ZEE Systems, Inc.

SERVICE LETTER 47-003-4

- 1.0 EFFECTIVITY: All SZ47-003-(X) Blower Assemblies.
- 2.0 PURPOSE: To provide an alternate kit for the replacement of the Blower Motor in the Blower Assembly.

FIG. 1

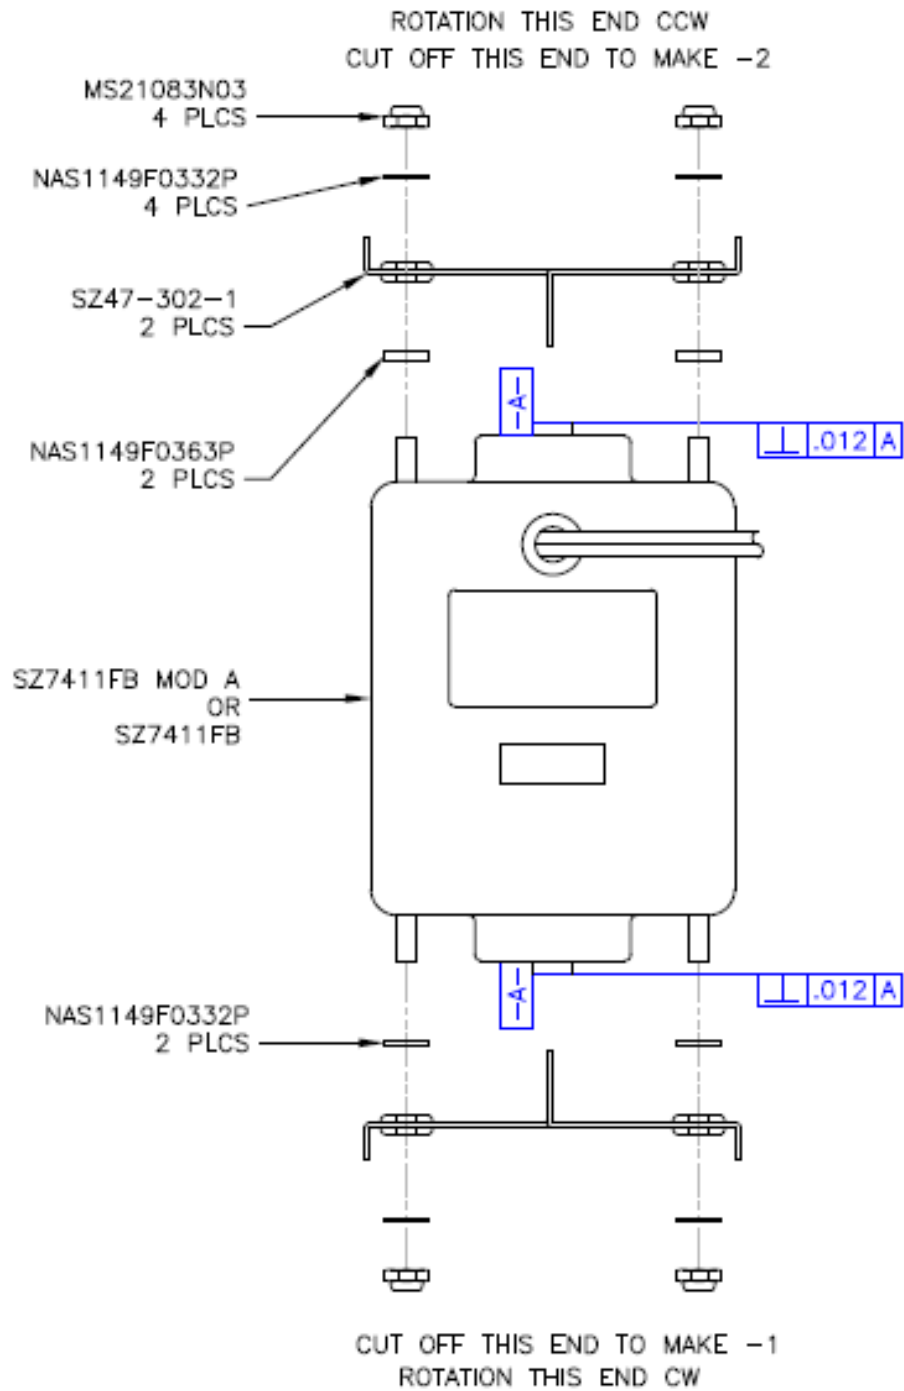
- 9.4 After the opposite shaft has been removed place 1 each Motor Support SZ47-302-1 on each end of the motor. Secure as shown on parts break down, see FIG. 1.

FIG. 2

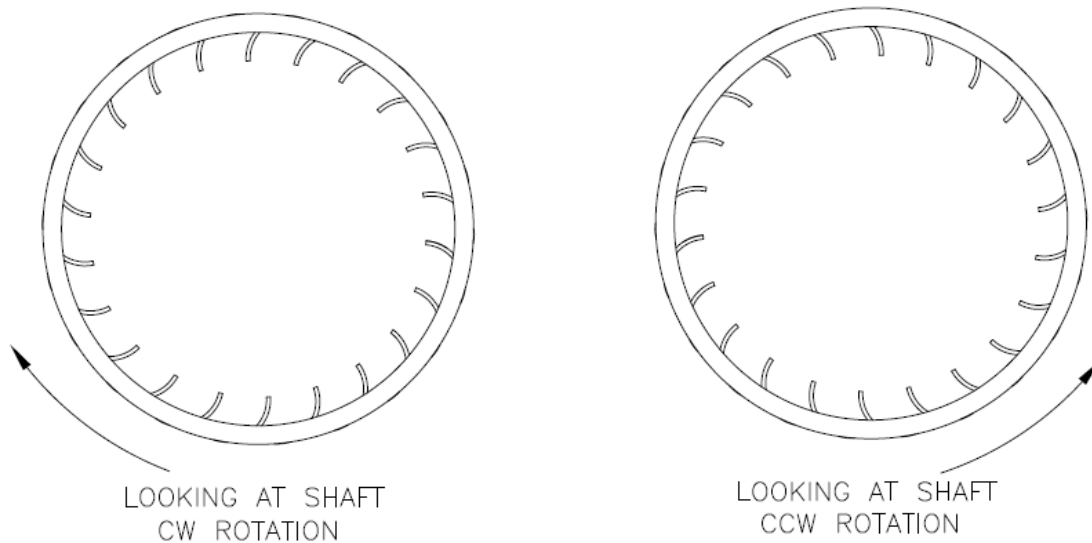
- 9.5 The 16-2527 Blower Wheel rotation must match the rotation of the shaft. See FIG. 2. Push the Blower Wheel onto the shaft until you have the same spacing as the old wheel. Fit the motor and wheel into the Lower Housing (17-2642). Adjust the position of the wheel on the shaft so it does not touch the housing on either side. Adjust the spacing of the wheel on the shaft as necessary. When the proper spacing is achieved attach the 916-901 Clip on the Blower Wheel.

FIG. 3

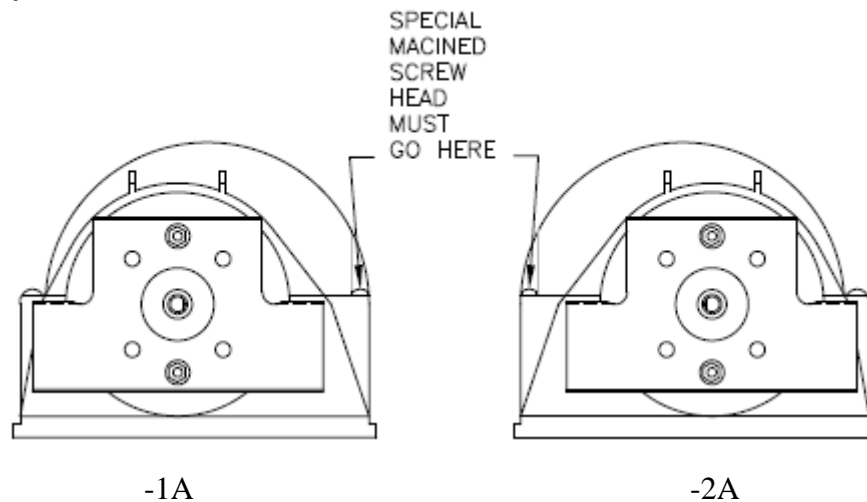
- 9.0 INSTRUCTIONS:
- 9.1 Remove the 8 Trac screws that hold the two blower housings together. Retain the screws for reassembly. Remove the Top Housing (17-2641). Note the spacing of the Blower Wheel in the Lower Housing (17-2642). Note that one of the screw heads has been machined down. Install in the same location, See FIG. 3.
